Project	IEEE 802.16 Broadband Wireless Access Working Group <http: 16="" ieee802.org=""></http:>			
Title	A More Flexible Dedicated Control for the Harmonized Map			
Date Submitted	2005-03-17			
Source(s)	Mark Cudak, Brian Classon Mark.Cudak@motorola.com			
	Motorola Inc.			
Re:	Proposes a more efficient and flexible structure for Dedicated DL Control			
Abstract	The normal map extension for HARQ has incorporated optional Dedicated DL Control into the HARQ sub burst IE formats for all types of HARQ—Chase, CTC IR and CC IR. The Dedicated Control IE as defined has several short comings with respect to efficiency, future expansion and flexibility that need to be resolved.			
Purpose	Adoption			
Notice	This document has been prepared to assist IEEE 802.16. It is offered as a basis for discussion and is not binding on the contributing individual(s) or organization(s). The material in this document is subject to change in form and content after further study. The contributor(s) reserve(s) the right to add, amend or withdraw material contained herein.

Note: The purpose of this revision, r1, was to harmonize 132 with the accepted changes in 115r3

Table 285KA Dedicated DL Control Configuration

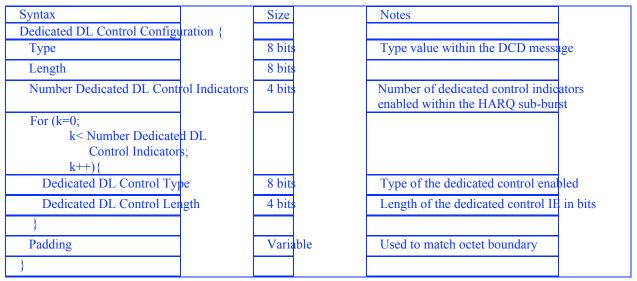
Table 285KA defines the format for the dedicated downlink control configuration which is used in the DCD message. The configuration defines the number dedicated downlink control types enabled and the respective size of each dedicated control IE. The order of the dedicated control indications within the HARQ sub-burst is identical to the order in which they are defined in the dedicated control configuration. If the Dedicate DL Control Configuration is not present in the DCD, then there are no dedicated control indicators in the DL HARQ sub-burst IEs.

Table 302m—UL HARQ Chase sub-burst IE format

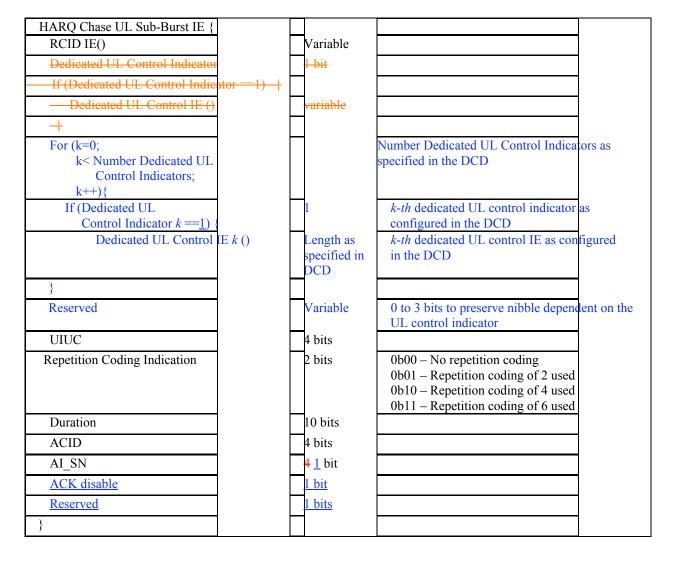
Tables 302m, 302n, and 302o below combine editing instructions to implement this solution in this contribution and those recommended in C80216e-05_115r3.doc. The editor should implement these changes for Tables 302m, 302n, and 302o from this contribution in place of 302m, 302n, and 302o from C80216e-05_115r3.doc.
